Street Tree Review Panel Report for A38 BREP Scheme D

Summary of Scheme D Proposals:

Figure 5 Tree loss on New Road (west of the A38)

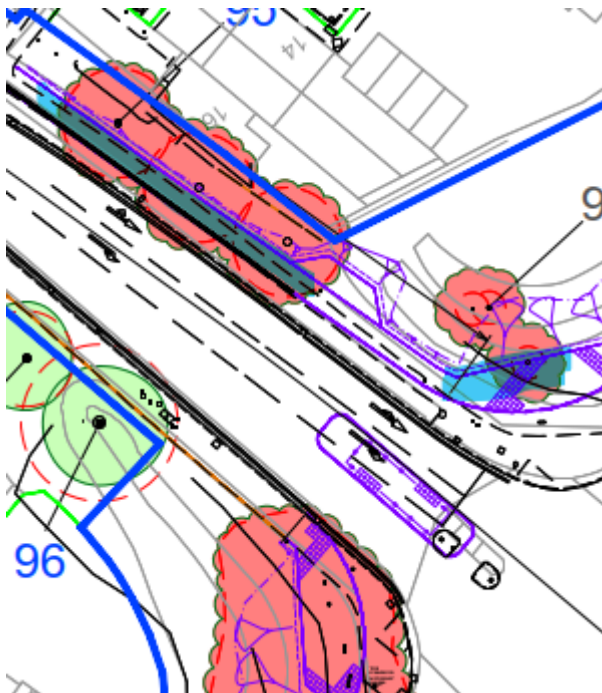
This section of New Road is being widened on the north side for the new signalised pedestrian crossing with central island. As this will require rebuilding the footpath closer to five trees, which shall require removal for the following reasons;

1. They are in the way of the proposed works and/or working area needed to safely build the works. The trees would cause great difficulty in delivering the works safely due to their location.
2. The works would damage trees and therefore potentially make them unsafe. This is because excavation within the tree root zone can damaged roots which significantly increases the probability of a tree becoming unstable and dangerous.

To achieve the BREP objectives there are no alternative design that would reduce the tree loss on New Road (west of the A38).

Figure 7 Proposed alternative solution New Road (east of the A38)

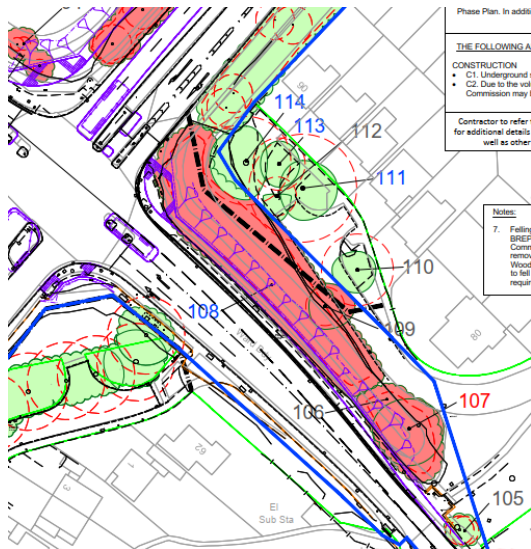
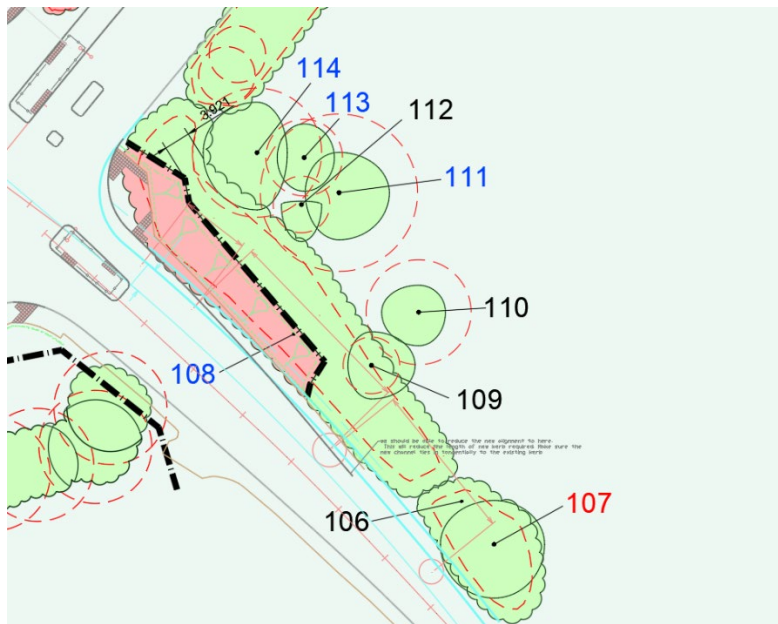
An alternative design has been proposed to remove the two lane merge as per Figure 7 below, which would significantly reduce the amount of shrub and tree clearance required on New Road. It must be noted however that this design is subject to an internal design audit followed by a road safety audit.

Vegetation removal for this proposal relates to cherry laurel bushes which have a tolerance to heavy pruning and is likely to thicken up rapidly post construction.

- It was pleased to note the proposed revisions to the design which could reduce tree loss further.
- The Panel noted that there have been previous concerns raised by neighbours regarding potential damage being caused by the trees on the north-west side of New Road, north of the junction with the A38.

However it is recommended that consideration be given to reducing the level of tree loss and vegetation clearance on New Road (east of the A38) and on the A38 where road widening is nominal. These areas are highlighted on the “Scheme D tree removal alternatives” drawing at the end of this report.
